REMARKS/ARGUMENTS

Claim Rejections under 35 U.S.C. 112

FIG. 4

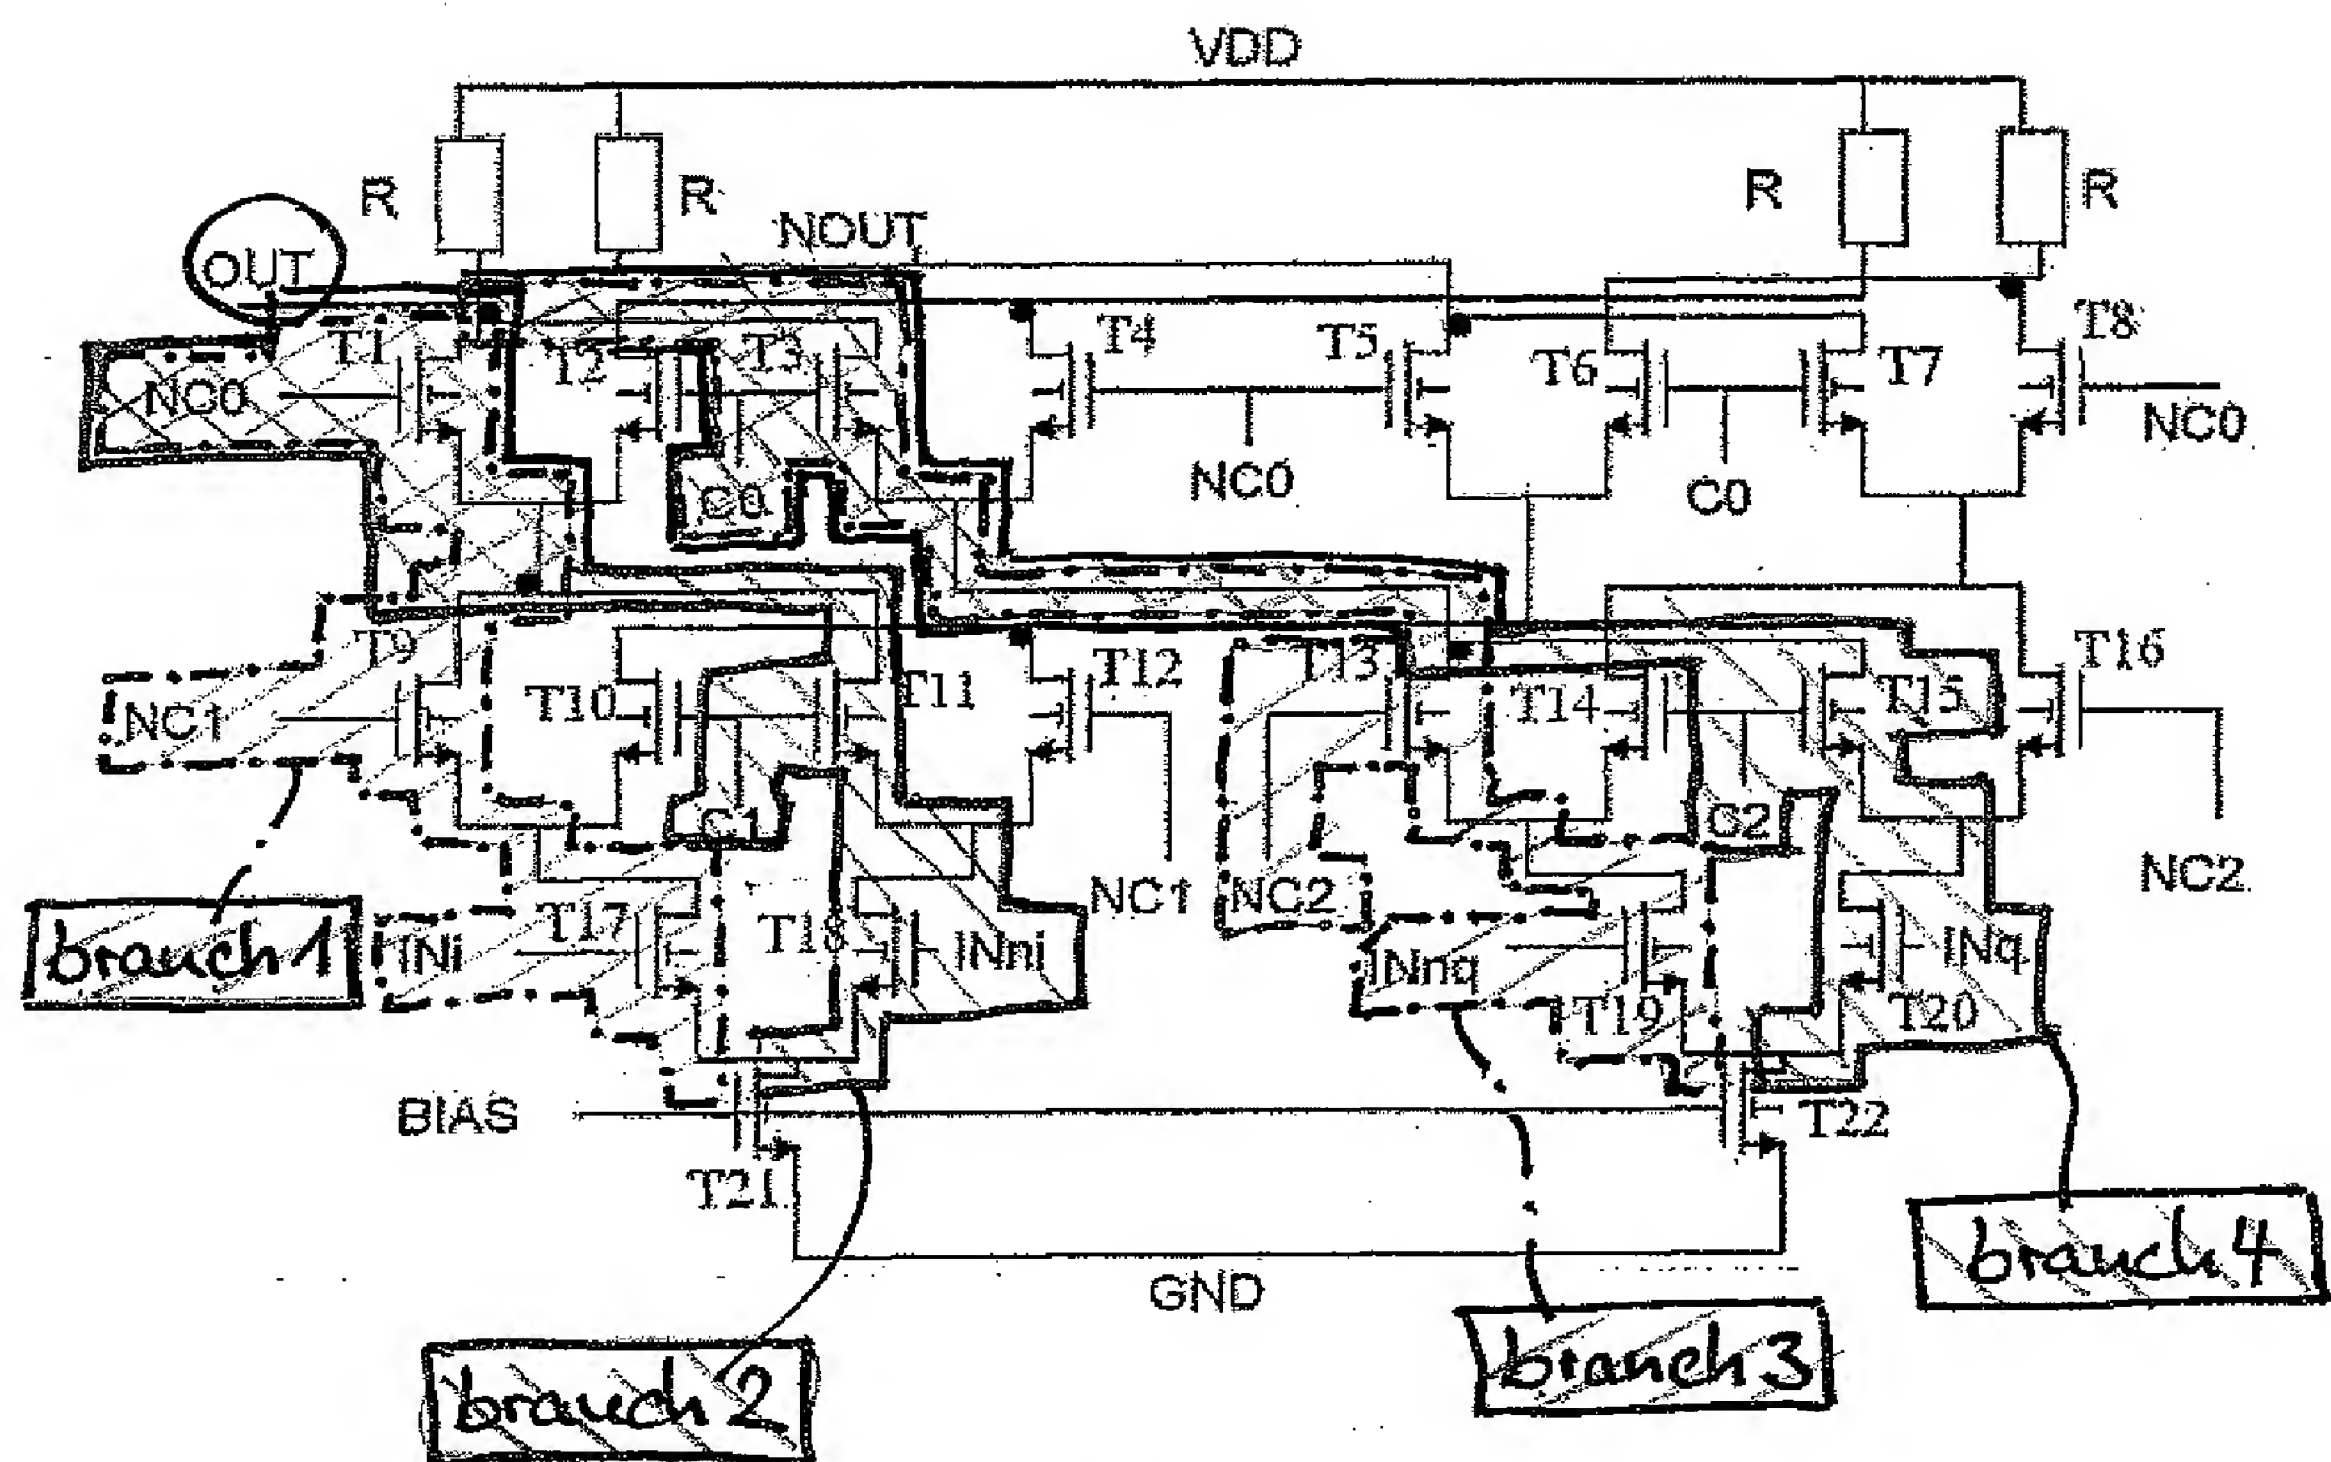
“it is not clear to the examiner how the logic works. What is being NANDed with what? It appears that the ANDed outputs are being ORed together, is this accurate? It is requested that applicant provide a diagram showing the logic gates with inputs corresponding to the equation. It may help to clear up the examiner's confusion.” (Office action, page 2)

Applicants respectfully assert that claim 1, as written, particularly points out and distinctly claims the subject matter which Applicants regard as the invention. However, in order to clear up any confusion that may exist with the Examiner, Applicants point out that Fig. 4 of the specification shows a circuit diagram of a phase selective unit (PSU).

“[0044] The above logic code comprises four branches which are OR-connected. The first branch is realized by the transistors T1, T9 and T17. The second is implemented by the transistors T1, T11 and T18. The third branch is implemented by transistors T3, T13 and T19. The fourth branch is implemented by transistors T3, T15 and T20.

[0045] The AND logic function, e.g. the first branch $NC0 \bullet NC1 \bullet INi$, is implemented differentially by current switching. The NAND logic is implemented by differentially switching the inputs in the current domain. The OR logic is implemented by adding the output current of the NAND logic in the loads R.”

Additionally, Applicants provide herewith a marked up copy of Fig. 4, which is marked up to illustrate the four branches representing the four AND logic functions: $NC0 \bullet NC1 \bullet INi$, $NC0 \bullet C1 \bullet INni$, $C0 \bullet NC2 \bullet INnq$ and $C0 \bullet C2 \bullet INq$. In particular, marked up Fig. 4 illustrates branch 1 (including T1, T9, and T17), branch 2 (including T1, T11, and T18), branch 3 (including T3, T13, and T19), and branch 4 (including T3, T15, and T20). By differentially switching the inputs (INi , $INni$, $INnq$, INq), the corresponding NAND logic functions, e.g., $\overline{NC0 \bullet NC1 \bullet INi}$ are implemented. The OR logic connecting these NAND logic functions is implemented by adding the output current of these NAND logic functions in the loads R. Applicants respectfully hope that above-provided discussion has cleared up any confusion that may have existed with the Examiner.
